STATE OF MAINE
DEPARTMENT OF TRANSPORTATION
16 STATE HOUSE STATION
AUGUSTA, MAINE 04333-0016

June 3, 2019
Subject: Base Reconstruction
State WINs: 024319.00 & 024319.55
Location: **Topsfield & Kossuth Township**
Amendment No. 1

NOT TO SCALE
TOPSFIELD - KOSSUTH ROUTE 6	WIN 024319.00	STATE OF MAINE DEPARTMENT OF TRANSPORTATION	SHEET NUMBER
TYPICAL SECTIONS		2431900 HIGHWAY PLANS	2 OF 2

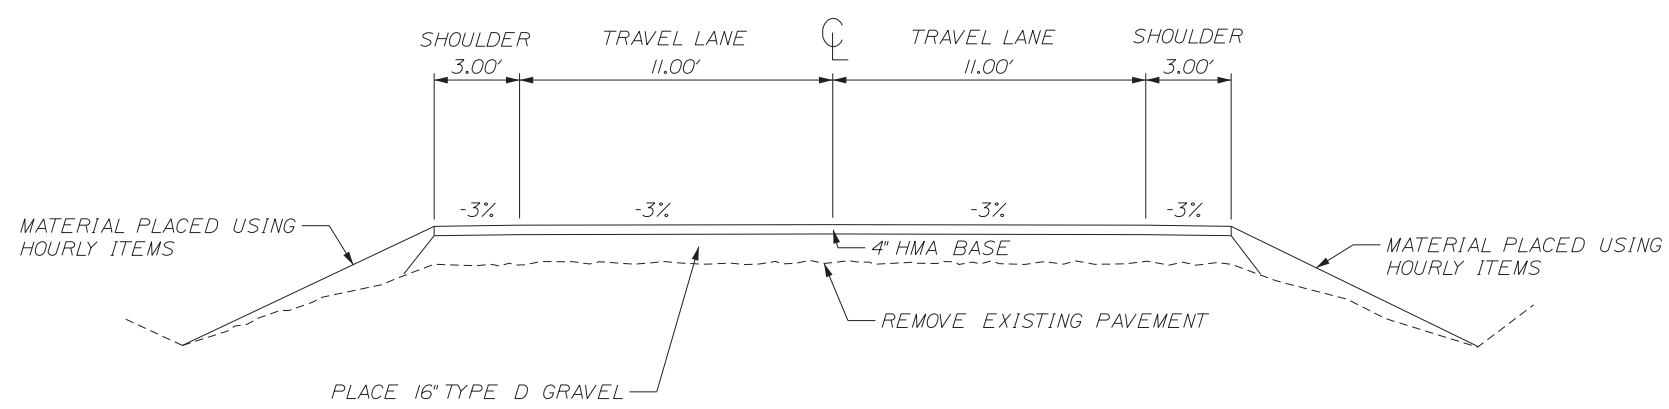
REMOVE page 30, TYPICAL SECTIONS, SHEET NUMBER 2 OF 2, and **REPLACE** with the attached, revised TYPICAL SECTIONS, SHEET NUMBER 2 OF 2.

Question: Based on the typical sections for the project is the intent to raise the entire grade of the road by 16"? This appears to be the case for areas being reconstructed after 2' of excavation, 3' of replacement gravel and 4" of pavement.

a. If this is not the intent, how will a transition be made between the two gravel treatments (3' of new gravel vs 1' of new gravel)? The section showing removing pavement and adding only 1' of gravel and 4" of pavement would not achieve a 16" raise in grade unless the depth of pavement removed within this section was replaced with that same thickness of gravel in addition to the 1' indicated on the details. The additional gravel would be necessary to maintain uniform profile along the project and for the 2 differing sections to tie together.

Response: Please see revised page 31 (Section 1, Typical 2-2). The noted stations will receive additional 4" gravel for a total gravel depth of 16".

REHABILITATION WITH 1' PROFILE ELEVATION
(SECTION 1)

STATIONS

12+28 - 14+49 LT&RT	41+85 - 44+40 LT&RT
22+80 - 24+10 LT&RT	44+40 LT - 46+40 LT
28+00 - 29+30 LT&RT	55+10 - 58+90 LT&RT
35+60 LT - 36+25 LT

TYPICAL SECTIONS

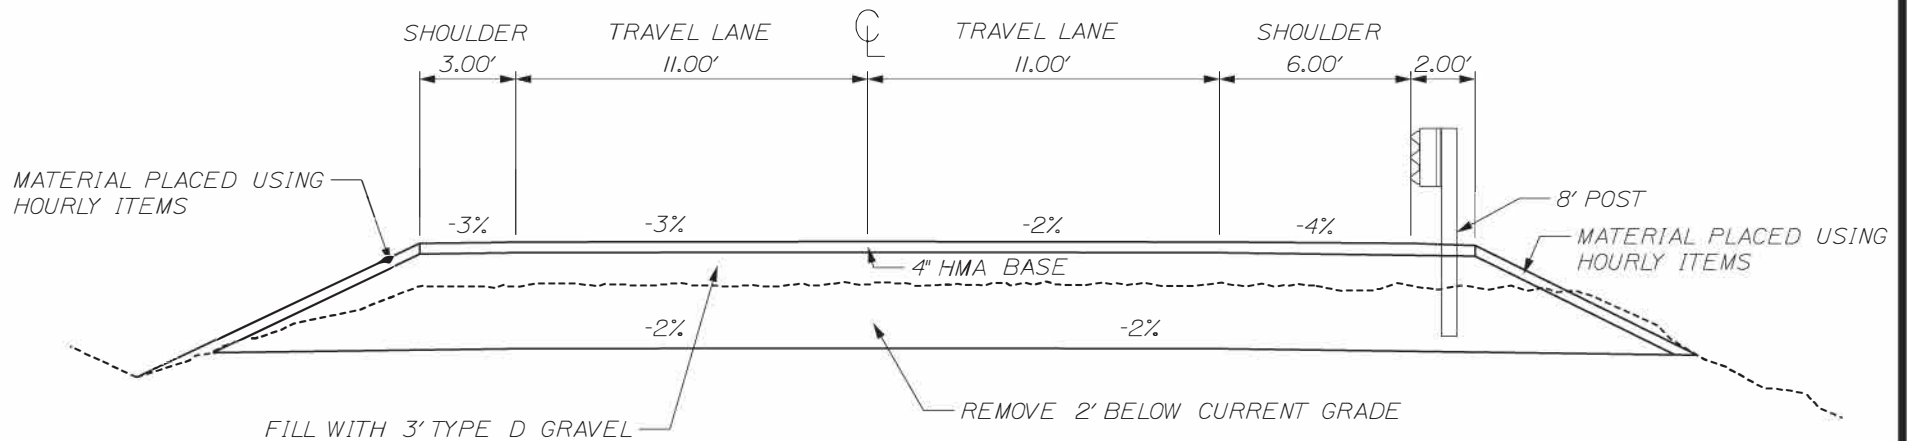
REMOVE pages 36 - 37, TYPICAL SECTIONS, 2 pages, and **REPLACE** with the attached, revised TYPICAL SECTIONS (WIN 024319.55), 1 page.

Question: The typical sections for the 0.31-mile section in Kossuth Twp., WIN 024319.55 on pg. 36 & 37 appear to be the same as shown on pg. 30 & 31 for the 0.96-mile section in Topsfield-Kossuth Twp., WIN 024319.00. Could the Department provide clarification on the details and stationing for the work on WIN 024319.55?

Response: Please see above changes to Typical Sections.

REHABILITATION OF 2' SUBGRADE MATERIAL
WITH 1' PROFILE ELEVATION
(SECTION 2)

STATION 168+00 TO 181+50 LT&RT
